Re: Response to Request for Site Conceptual Model and Soil & Water Investigation Work Plan
Atlantic Richfield Company (a BP affiliated company) Station #276
10600 MacArthur Boulevard
Oakland, California
ACEH Case #RO0002565

Re: Response To Request For Site Conceptual Model and Soil and Water Investigation Work Plan, Atlantic Richfield Company Station No.276, 10600 MacArthur Boulevard, Oakland, Alameda County, California; ACEH Case No.RO0002565.

Subject: Fuel Leak Case No. RO0002565 and GeoTracker Global ID T0600108312, ARCO
#0276, 10600 MacArthur Boulevard, Oakland, CA 94605

Figure 1
MW-2 Concentrations and Ground-Water Elevations vs. Time
Atlantic Richfield Company Station #276
10600 MacArthur Boulevard, Oakland, California

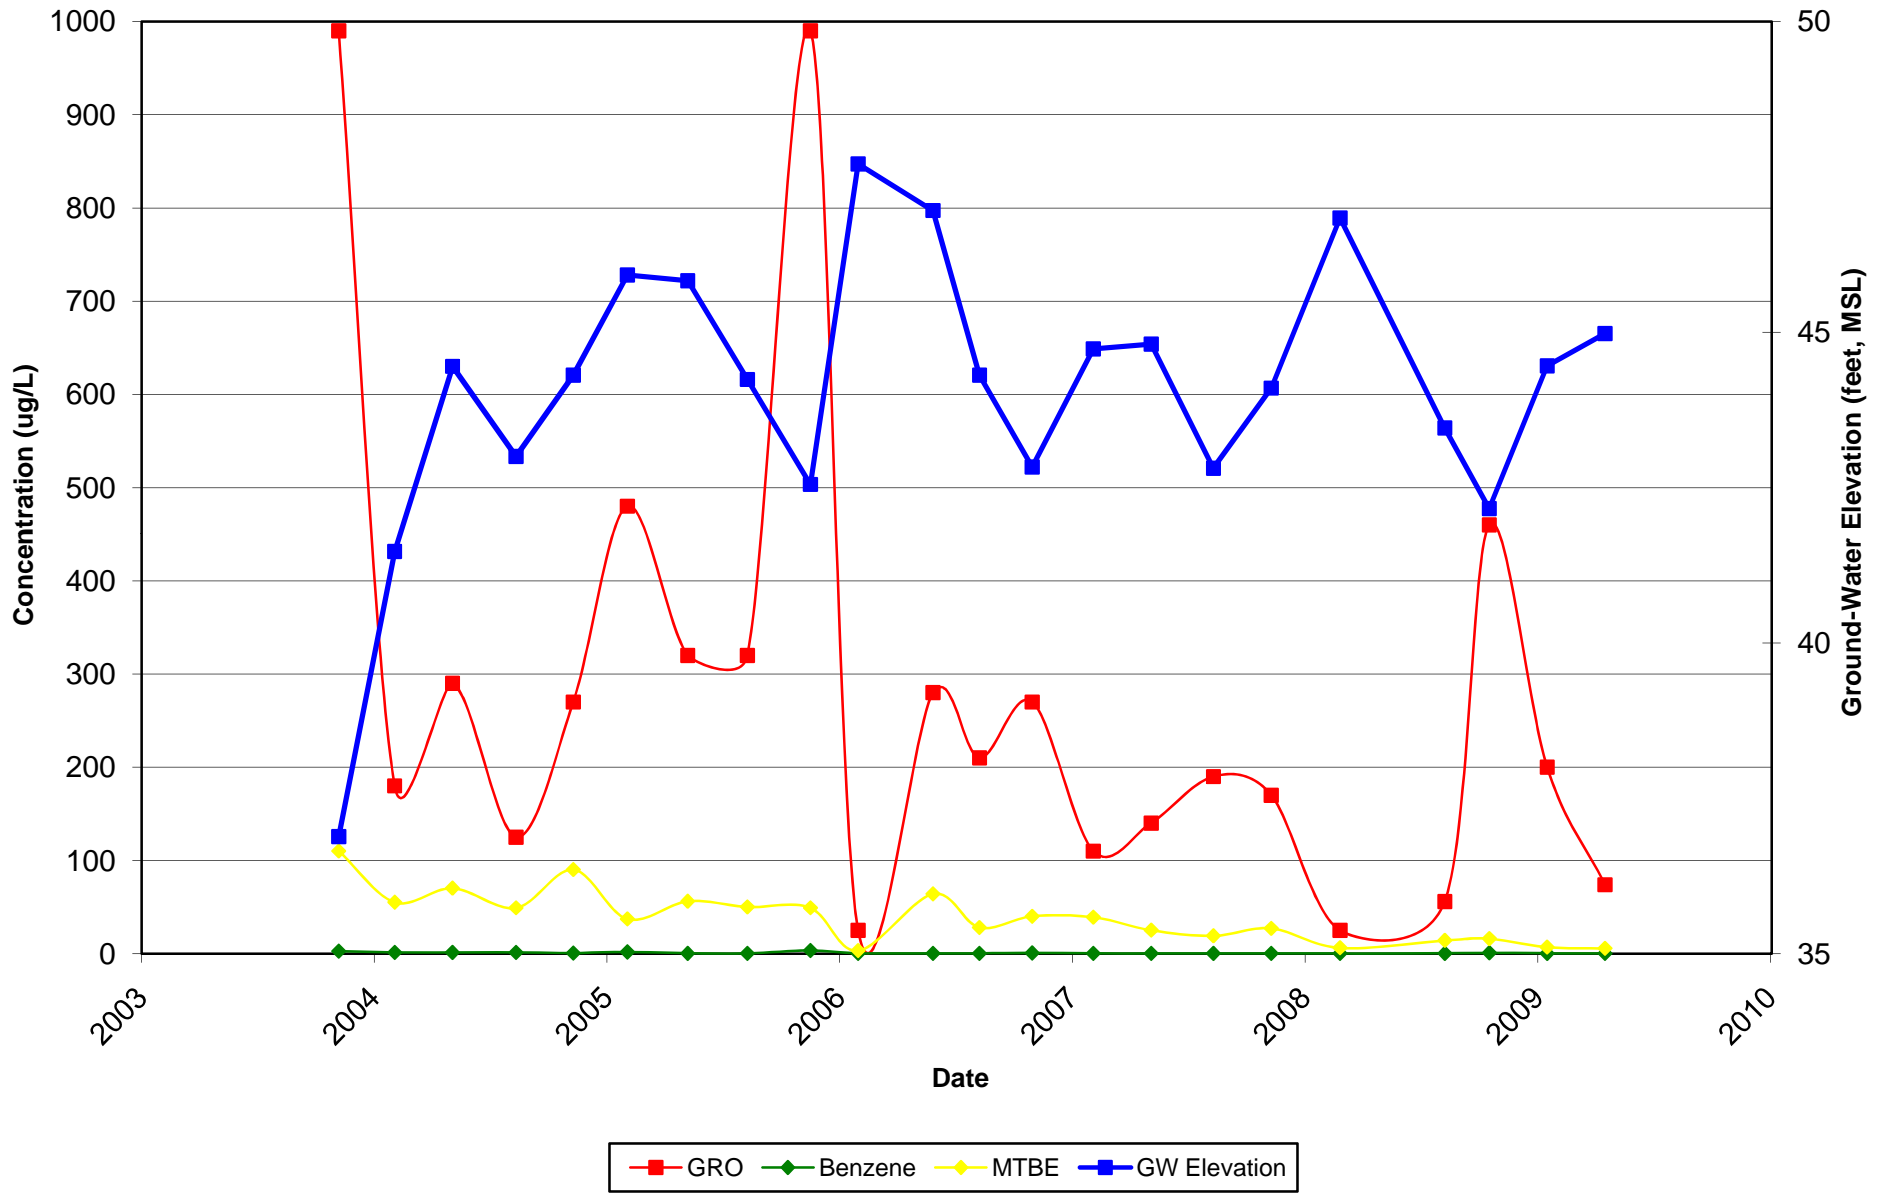
In the ACEH directive letter, concerns were expressed regarding concentrations of gasoline range organics (GRO) in well MW-2 (460 µg/L) and Methyl tert-butyl ether (MTBE) in well MW-8 (260 µg/L) observed during the Fourth Quarter of 2008. ACEH stated that “based on the locations of the monitoring wells in relation to the calculated ground-water flow direction, it appears that the ground-water contaminant plume is undefined in the down-gradient direction.”

1. **Soil and Groundwater Characterization** – During the most recent groundwater sampling event conducted on October 21, 2008, TPH-g was detected as high as 460 µg/L in a groundwater sample collected from monitoring well MW-2 and MTBE was detected as high as 260 µg/L in a groundwater sampling collected from monitoring well MW-8. Based on the locations of the monitoring wells in relation to the calculated groundwater flow direction, it appears that the groundwater contaminant plume is undefined in the down-gradient direction. Please justify that the groundwater contaminant plume is defined or submit a scope of work to address the above-mentioned concerns by the date specified below.

Since the Fourth Quarter 2008 sampling event, ground-water samples have been collected from wells MW-2 and MW-8 during the first and second quarters of 2009. GRO were detected at concentrations of 200 µg/L on 20 January 2009 and 74 µg/L on 21 April 2009 in well MW-2. MTBE was detected at concentrations of 35 µg/L on 20 January 2009 and 48 µg/L on 21 April 2009 in well MW-8. As evident from the most recent ground-water sampling event, GRO and MTBE concentrations within wells MW-2 and MW-8, respectively, have decreased significantly since Fourth Quarter 2008. Attached figures 1-6 depict concentrations of GRO, benzene, and MTBE and ground-water elevations versus time for wells MW-2, MW-4, MW-5, MW-6, MW-7, and MW-8. It should be noted that non-detect concentrations are plotted on the graphs as half of the

laboratory reporting limit. Following a review of Figures 1 and 5, it appears that concentrations within wells MW-2 and MW-8 have decreased by an order of magnitude since monitoring activities began in 2003. Based on these observations, further characterization of ground water in the down-gradient direction does not appear warranted due to low concentrations and the overall declining trends observed within wells MW-2 and MW-8.

Figure 4
MW-6 Concentrations and Ground-Water Elevations vs. Time
Atlantic Richfield Company Station #276
10600 MacArthur Boulevard, Oakland, California

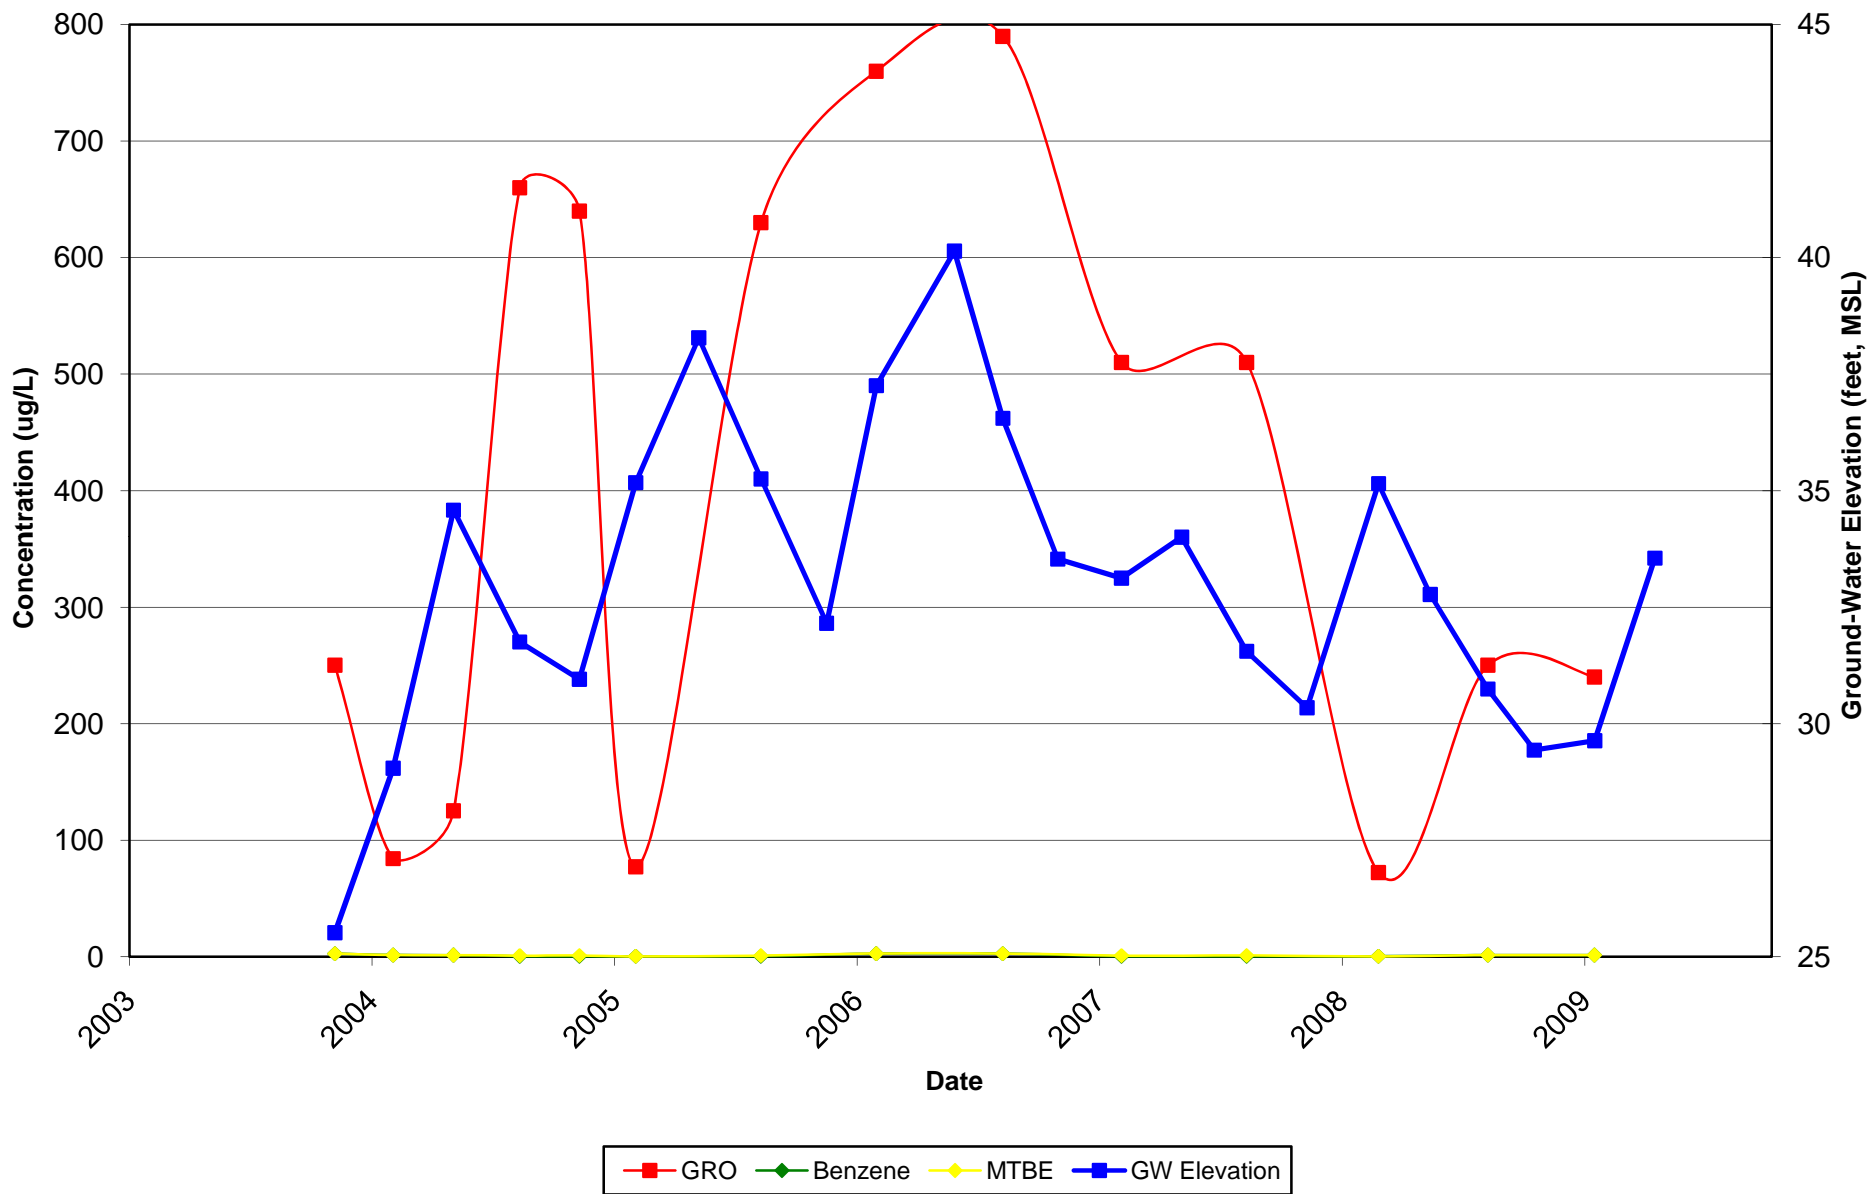
Concentrations of benzene and MTBE associated with the Site have not exceeded their respective ESLs during the past four quarters of ground-water monitoring and sampling. GRO concentrations associated with the Site have exceeded the ESL within wells MW-2 (460 µg/L – 10/21/2008), MW-6 (250 µg/L – 8/12/2009 and 240 µg/L – 1/20/2009) and MW-7 (2,300 µg/L – 8/12/2008 and 4,700 µg/L – 1/20/2009). Historic detected concentrations of GRO within wells MW-6 and MW-7 have been qualified in past laboratory analytical reports. Samples collected from wells MW-6 and MW-7 and analyzed for GRO during the first quarter of 2008 were qualified by the laboratory with the following statement: “The hydrocarbon pattern in the sample does not match that of the gasoline standard used to calculate results. The values reported for these samples are

in part due to the tetrachloroethene peak that falls within the GRO (C6-C12) window.” GRO concentrations detected within well MW-6 have also been qualified by the analytical laboratories during the first quarter 2009 and the first and third quarters of 2007 stating “quantitation of unknown hydrocarbon(s) in sample based on gasoline” and “hydrocarbon results partly due to individual peak(s) in quantitation range,” respectively. It appears that the elevated concentrations of GRO may be attributed to the presence of PCE. Observed GRO, benzene, and MTBE concentrations within the remaining wells associated with the Site have been below the established ESLs for ground water that is not a current or potential source of drinking water since 12 August 2008.

PCE Iso-Concentration Contours Map
 20 January 2009

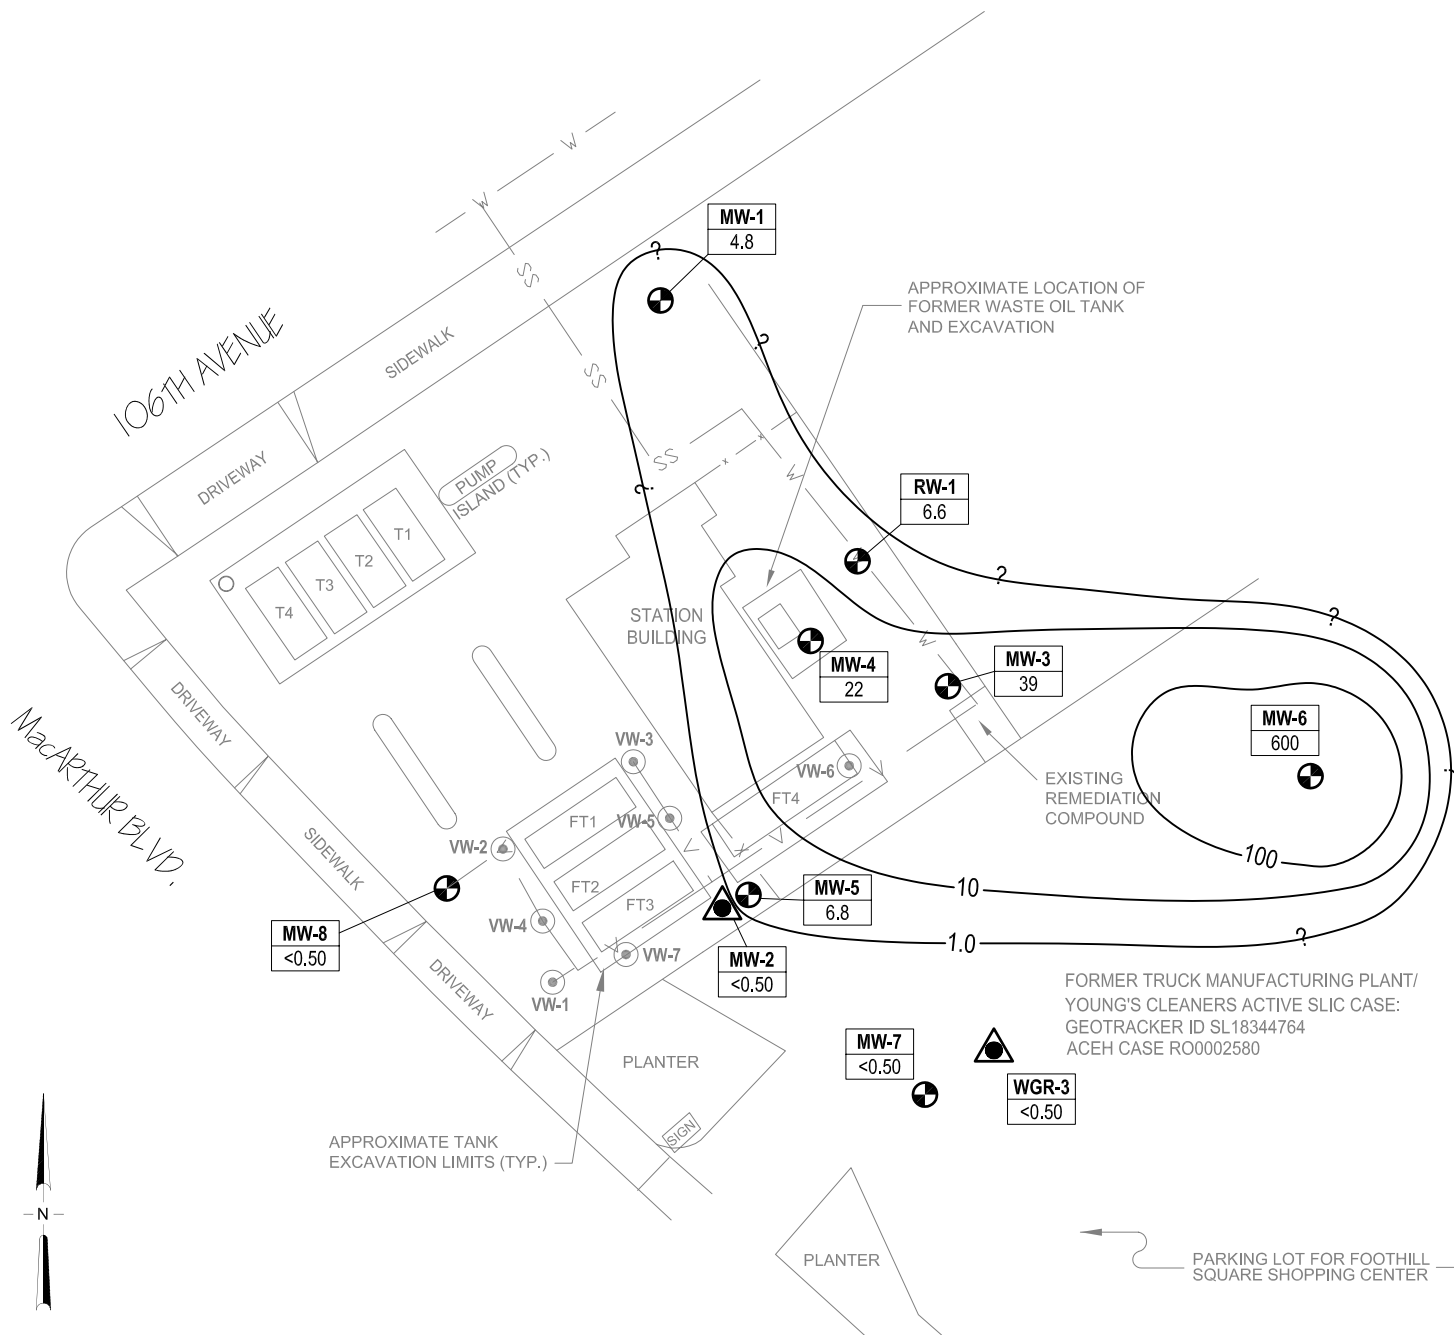
Based on the groundwater analytical data, it appears that contaminant volatilization to indoor air from PCE exposure may be a completed exposure pathway and hence, may be a data gap that needs to be addressed. If additional data gaps (i.e. post remediation confirmation sampling, etc.) are identified in the SCM, please include a proposed scope of work to address those data gaps in the work plan due by the date specified below. Once all data gaps have been addressed, the site may qualify for case closure consideration.

The ACEH letter also states that the presence of tetrachloroethylene (PCE) within on-site wells could suggest that a completed exposure pathway may exist due to volatilization to indoor air. The contaminant plume of PCE beneath the Site and conduct of a vapor intrusion assessment are not the responsibility of Atlantic Richfield Company (ARCO). It has been documented that the former Young Cleaners (Geotracker ID SL 18344764 and ACEH Case RO0002580) located within the Foothill Square Shopping Center at 10700 MacArthur Boulevard, immediately southeast of Station No. 276, is the responsible party for the PCE contaminant plume. The former truck manufacturing plant located to the southeast of the Site could also have contributed to the PCE contamination. The highest observed PCE concentrations associated with Station No. 276 have been detected within wells MW-5, located along the southeastern boundary of the Site, and MW-6, located off-site to the east-southeast on the Foothill Square Shopping Center property. A PCE iso-concentration contour map containing data from First Quarter 2009 is provided as Drawing 1. This map suggests that the PCE present at the Site is due to migration from an off-site source to the southeast. Consequently, it is requested that a vapor intrusion assessment near the station building be performed by the former Young’s Cleaners and/or the former truck manufacturing plant responsible parties.
